PROPOSED AMENDED GROUND FLOOR PLAN

Client	The Duchy of Lancaster		
Contract	Root Farm Dunsop Bridge		
Drawing title	Proposed amended floor plan detail to L Shaped Building		
Scale	Job No.	Drg No.	D
1:50	HB105	S 09

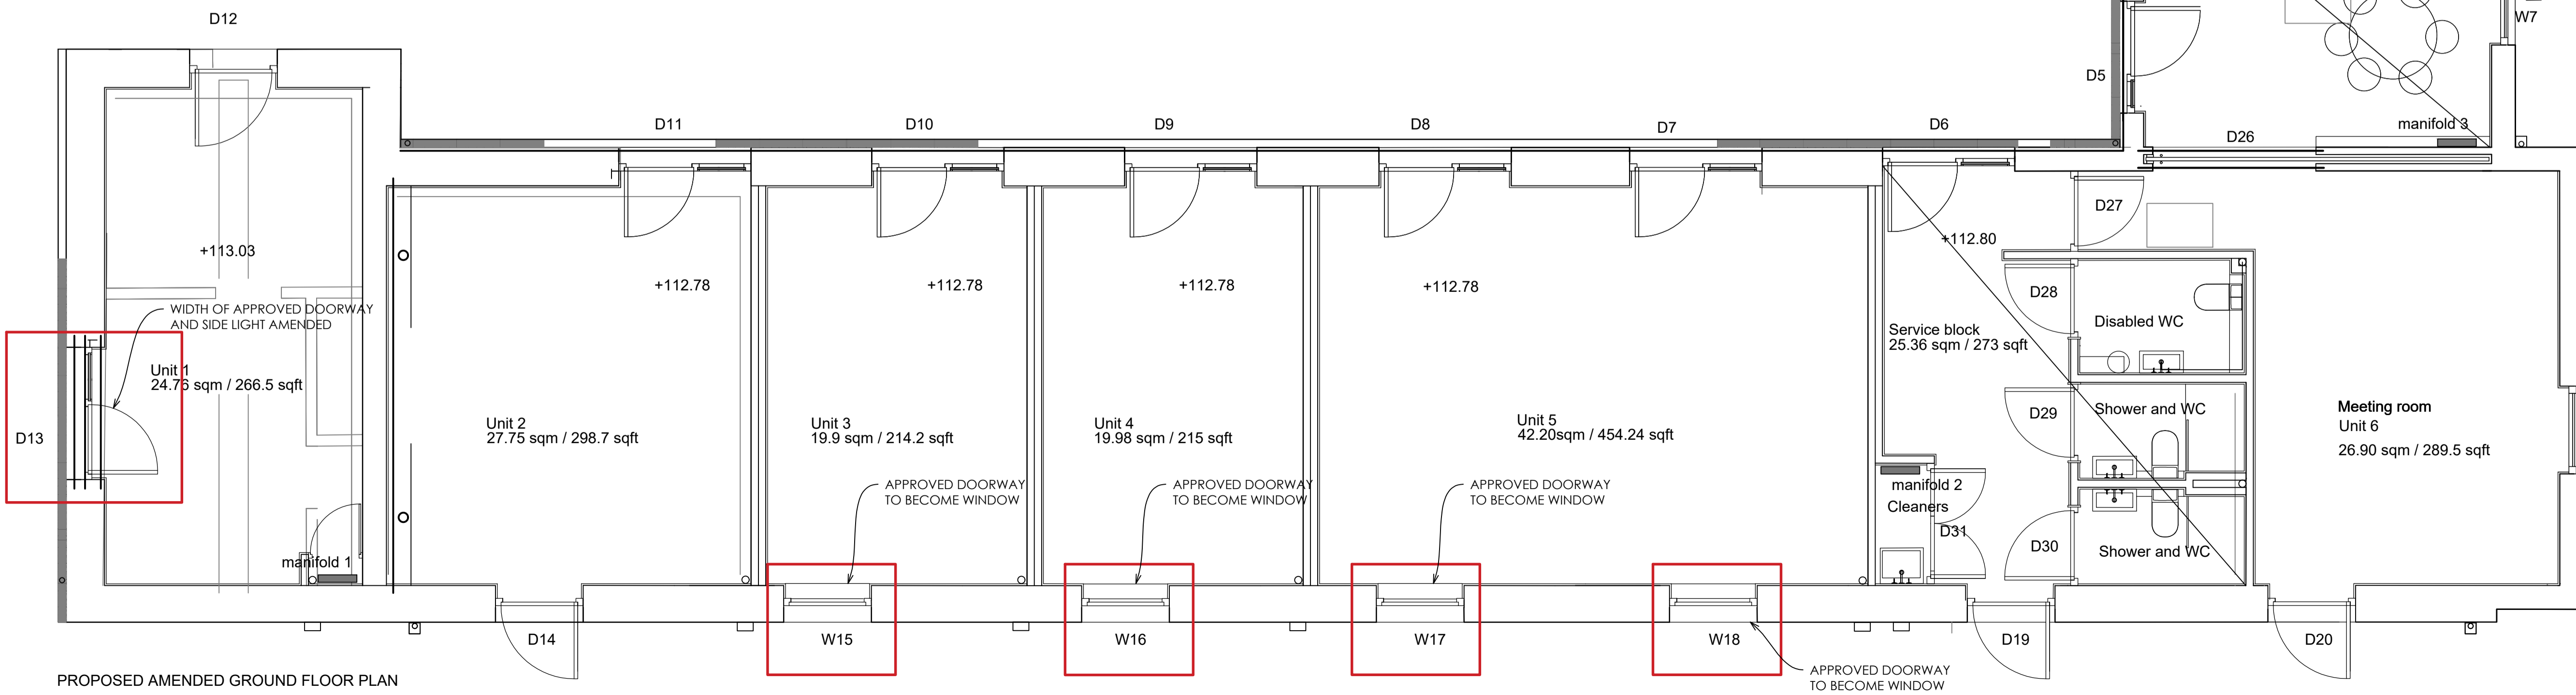
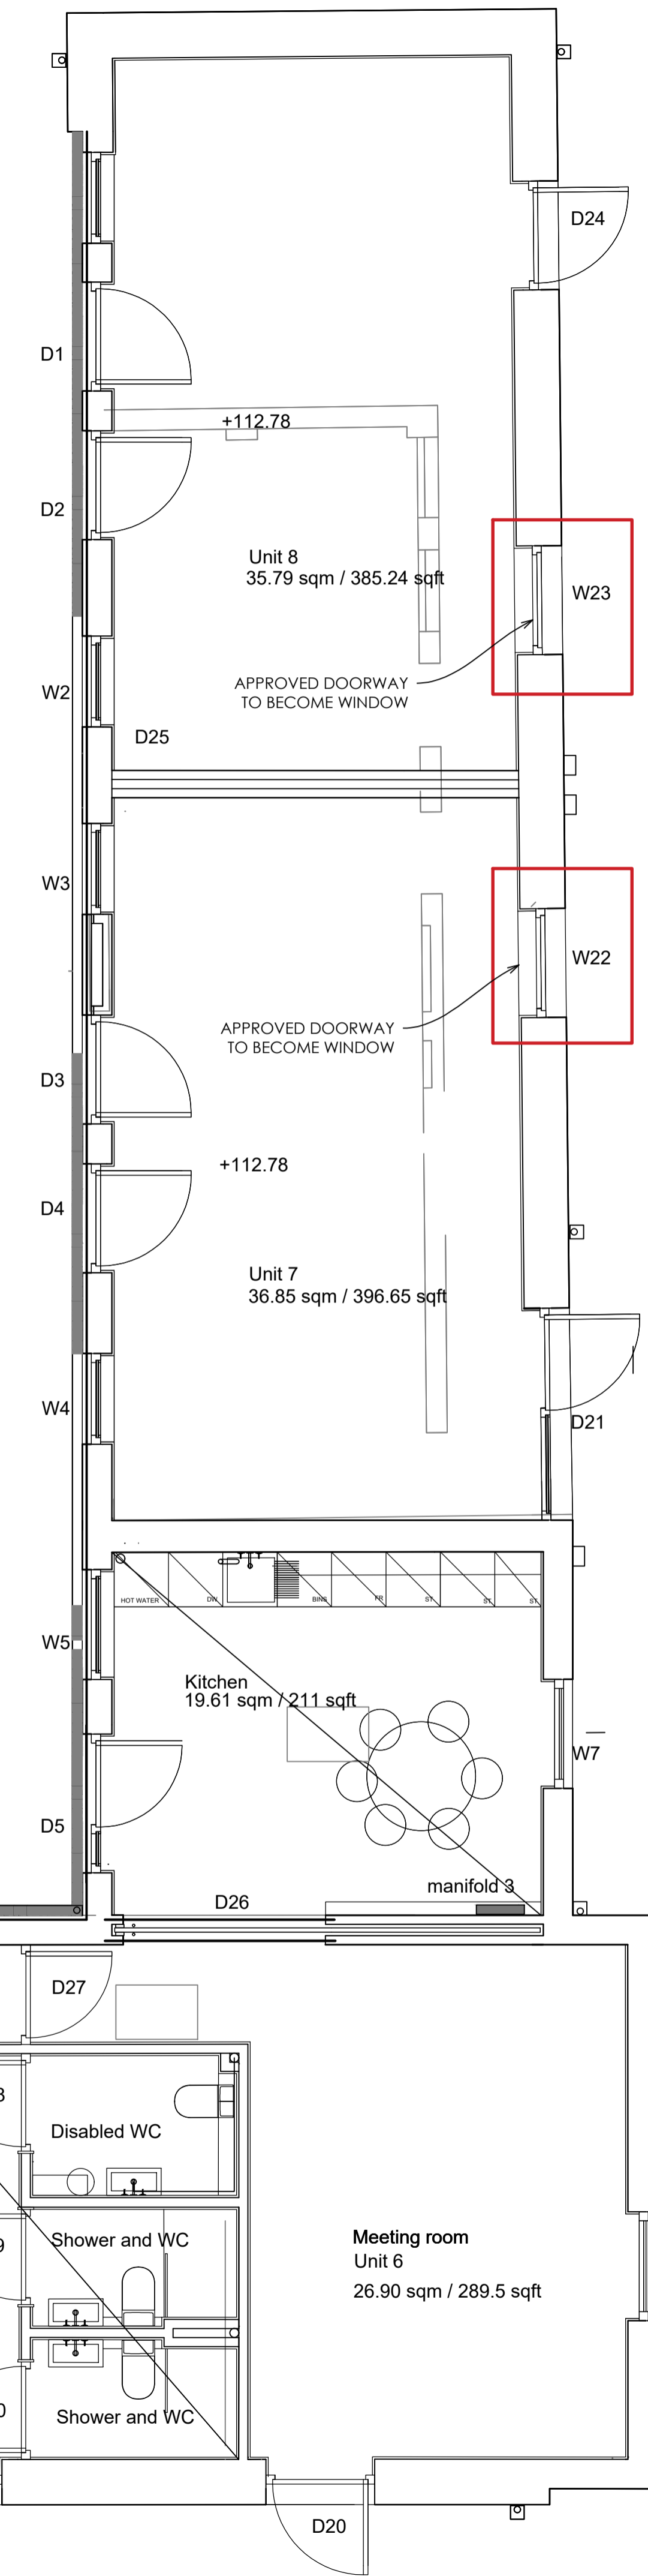
03.04.24 external doors and windows amended, doors to compartment walls removed, note added re fire compartmentation to ALL separating walls manifestation added to glass, vision panel added to D27, DIS WC layout amended, kitchen accessibility note added, notes added in bold for reg compliance

REV A 16.05.24 due diligence
 150mm stone facing
 100mm foul drain to each unit confirmed
 FULL radon measures added
 due diligence notes added
 unsupported round bearing slab detail incorporated

REV B 30.07.24 contract drawing amendments
 solid ground floor specification amended and tiled areas shaded

REV C 05.08.24 contract drawing amendments
 FINAL FLOOR LEVELS CONFIRMED
